Validation Opinion for Post Registration Changes

Report for:
CGN Wind Power Co., Ltd.

CDM project for
Inner Mongolia Wuliji Wind Farm Project

LRQA Reference : A20437-B-PRC Version 01.2
Date : 17/05/2013

Figure 1. The arrangement of meters for the proposed project

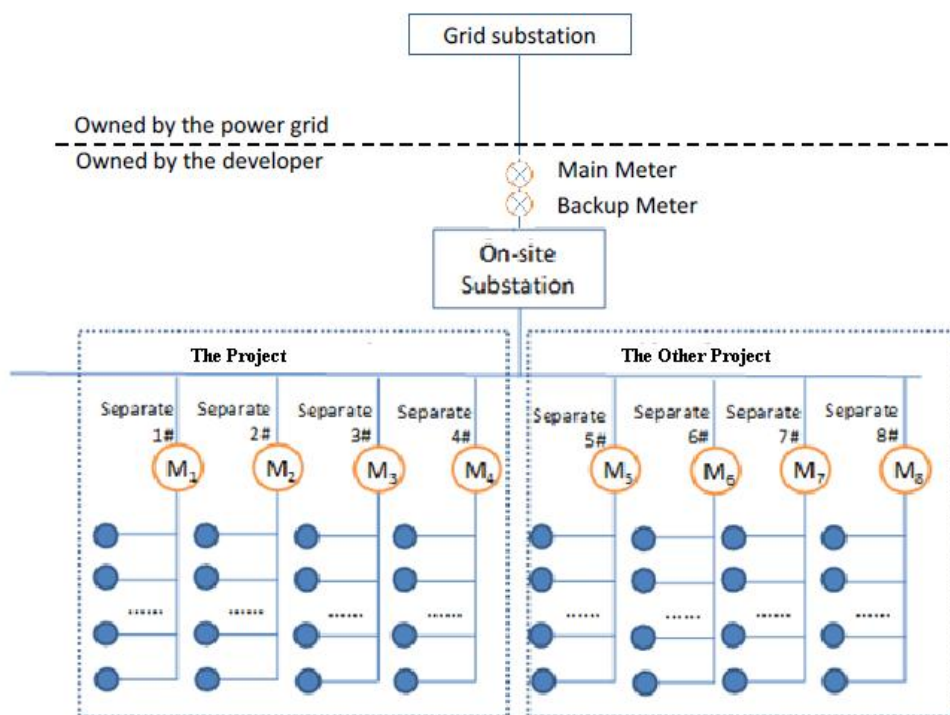
In the real practice (as reflected in Figure 1 below), the main meter (accompanying with a backup meter) acting as the settlement meter is installed at the outlet of the project site substation, which is stipulated by the Power purchase agreement (PPA) between the project owner and the grid company.

The separate meters M1~M8 are installed at the project site so that the electricity generation can be monitored for each wind farm separately to calculate the share of this wind farm of the total net electricity exported to the grid. Meters M1~M4 are installed in connection line 1#~4# respectively to monitor the generation from the project; Meters M5~M8 are installed in connection line 5#~8# respectively to monitor the generation from the other wind farm project. Figure 1 below describes the monitoring points:

The location of the main meter was changed as required by the PPA, and the installation of additional meters (M1~M8) is for determining the contribution of the project activity to the total net electricity supply by the two projects.

Based on the site inspection of metering system and the document review including the revised MP contained in the revised PDD, the PPA and the Wind turbines connection diagram, the team confirmed that the proposed revision is to use more applicable monitoring method under the situation of sharing the same transformer located at the on-site substation and transmission line with the other wind farm project. The applied method is applicable to the real practice of the project and can be implemented by the PP. Under the revised monitoring plan, the main meter and meters M1~M8 will be used to determine EG_y. All these meters are in the same provisions applied to all the meters concerned related with the frequency of measurement and recording, accuracy class, calibration frequency, and QA/QC procedures. The monitored data from the main meter will be cross-checked against commercial records. Therefore the proposed revision does not reduce the level of accuracy in the monitoring and verification process. The revision enhances monitoring and verification in a more complete manner reflecting the actual implementation of the monitoring with regard to the actual connection structure and metering system used and does not reduce completeness of the monitoring and verification process.
